Point Beach Nuclear Plant

Response to Request for Additional Information
10 CFR 50.55a Requests Relief Requests RR-19 and RR-20
Associated With Examination of the Reactor Pressure Vessels
Fourth Ten-Year Inservice Inspection Program Interval

RESPONSE TO REQUEST FOR ADDITIONAL INFORMATION

Drawing 1
Point Beach Nuclear Plant, Unit 1 and 2
RPV Support Configuration
NOT TO SCALE

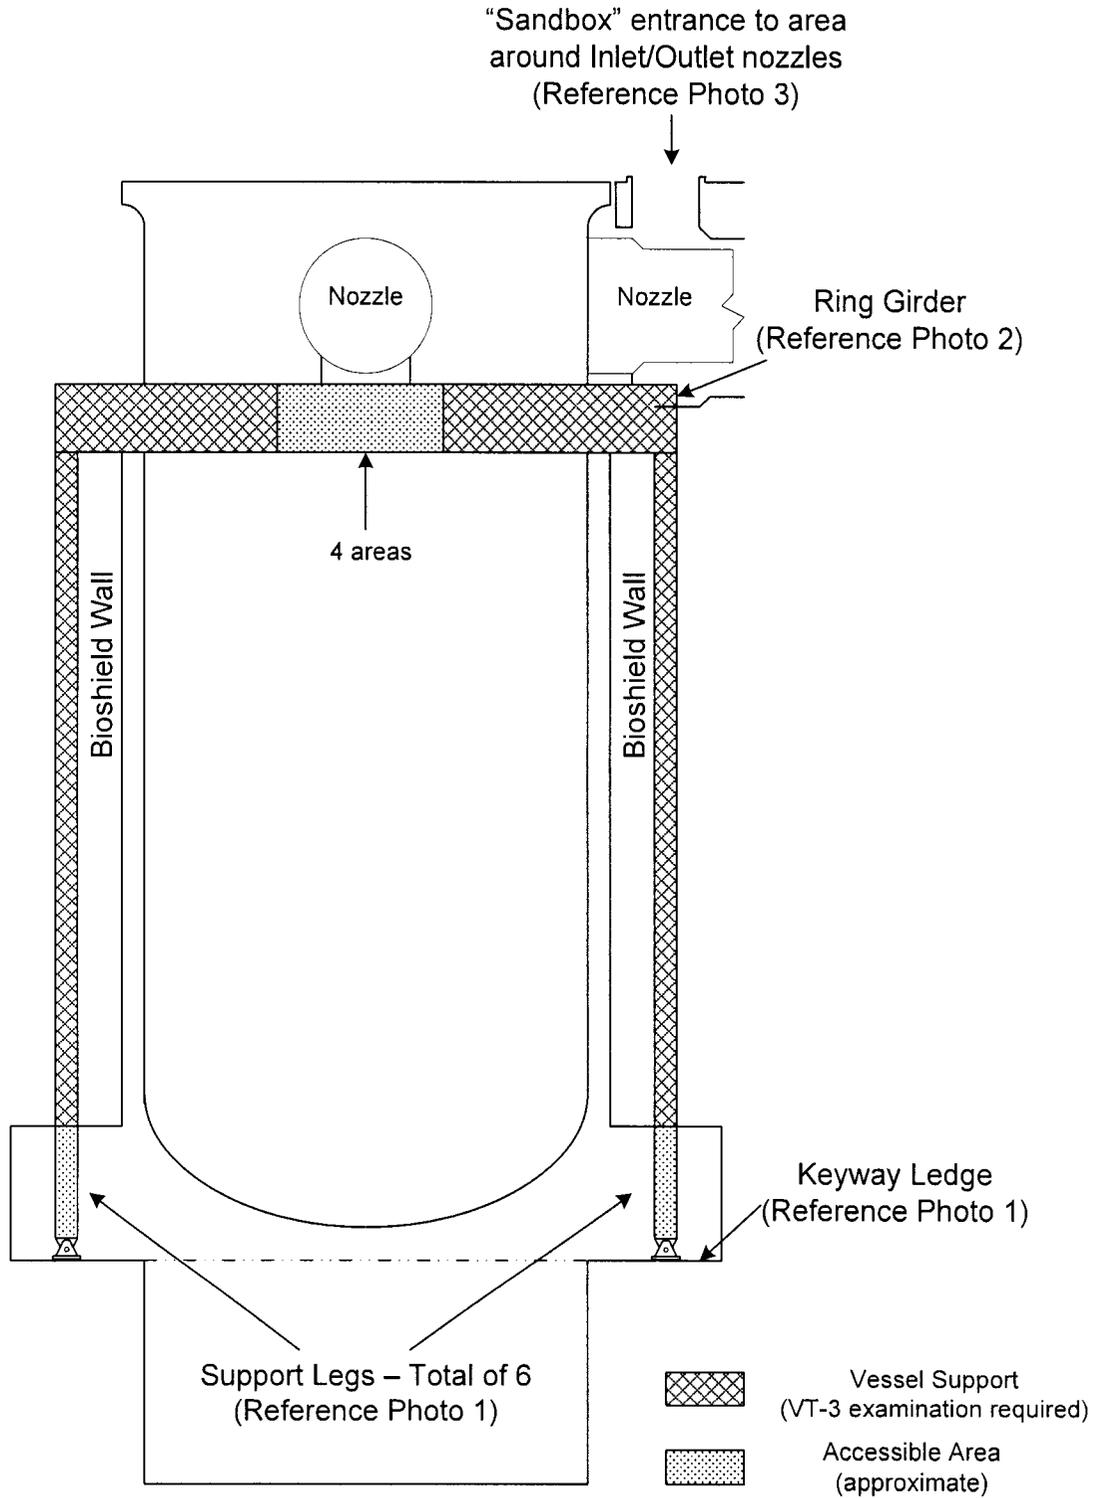
- a. *Provide the number, location, component identification numbers for, and identify all welds associated with the RPV supports for Point Beach Plant, Units 1 and 2.*
- b. *Provide a representative drawing of a RPV support which shows the areas required to be inspected and any interferences which make the required inspections impractical.*

- a. The Category F-A, Item F1.40, portion of the RPV support structure for each unit consists of a ring girder supported by six legs. There are two attachments welded to the RPV (considered to be Category B-K as discussed in RR-18) and a weld deposit support pad on each nozzle that sits on the ring girder. The welds within the Category F-A support assembly as a whole are not individually identified. The component supports (rings/legs) for the Point Beach Nuclear Plant (PBNP) RPVs are identified as RPV-Support for each unit.
- b. See Drawing 1 and Photo 1, 2, and 3 in Enclosure 2.

Drawing 2
Point Beach Nuclear Plant, Units 1 and 2
RPV Upper Shell to Flange Configuration
NOT TO SCALE

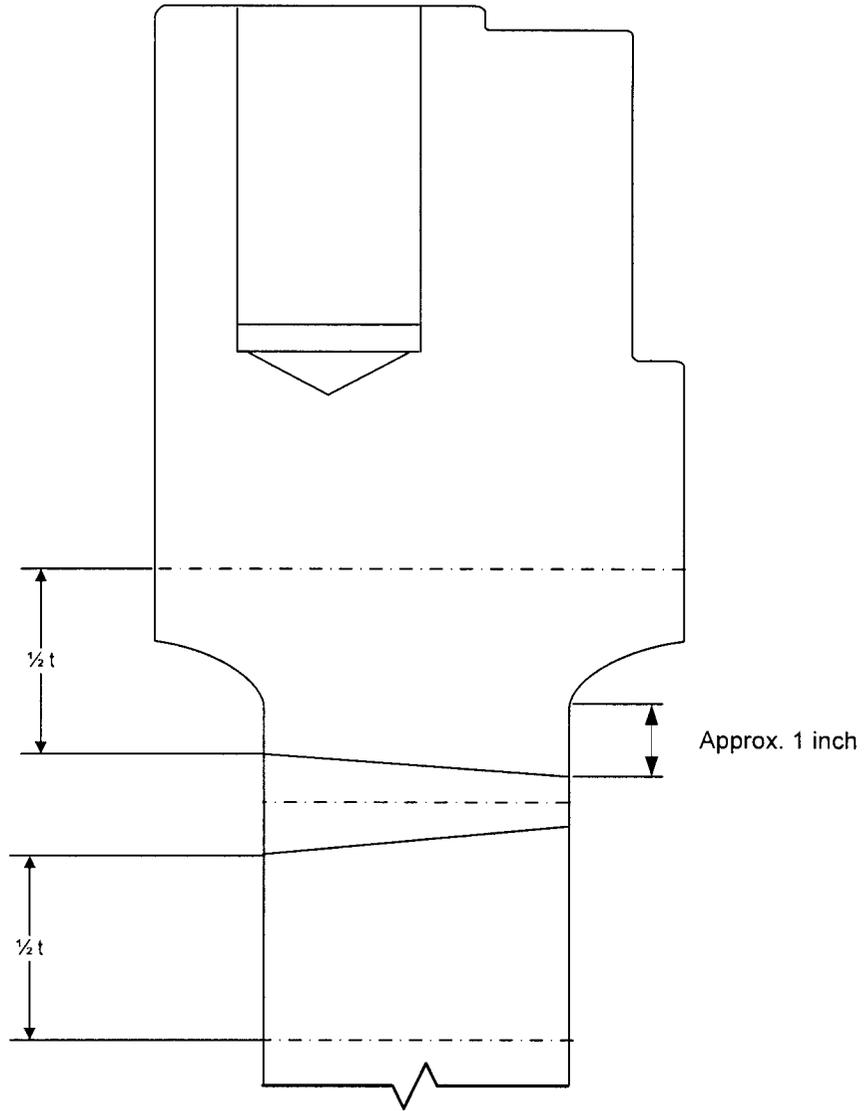
- a. Provide the identification numbers for the RPV Upper Vessel Shell-to-Flange welds.*
- b. Provide drawings of the RPV Upper Vessel Shell-to-Flange welds.*

- a. The weld identification numbers for the PBNP RPV shell-to-flange welds are RPV-14-683 for each unit.
- b. See Drawing 2 in Enclosure 2.

The RPV examination vendor reviewed PBNP drawings and has estimated about 60 percent coverage will be obtained on welds RPV-14-683. This is due to the configuration of the flange forging and its proximity to the weld (see Drawing 2 in Enclosure 2). The design of the flange forging is such that there are both inside and outside surface tapers that interfere with placement of remote examination modules. In addition, the outside surface of the RPV is inaccessible due to its placement inside the biological-shield wall (Photos 2 and 3 in Enclosure 2). The RPV examination vendor will perform examinations designed to achieve the maximum coverage possible utilizing PDI qualified procedures and personnel.
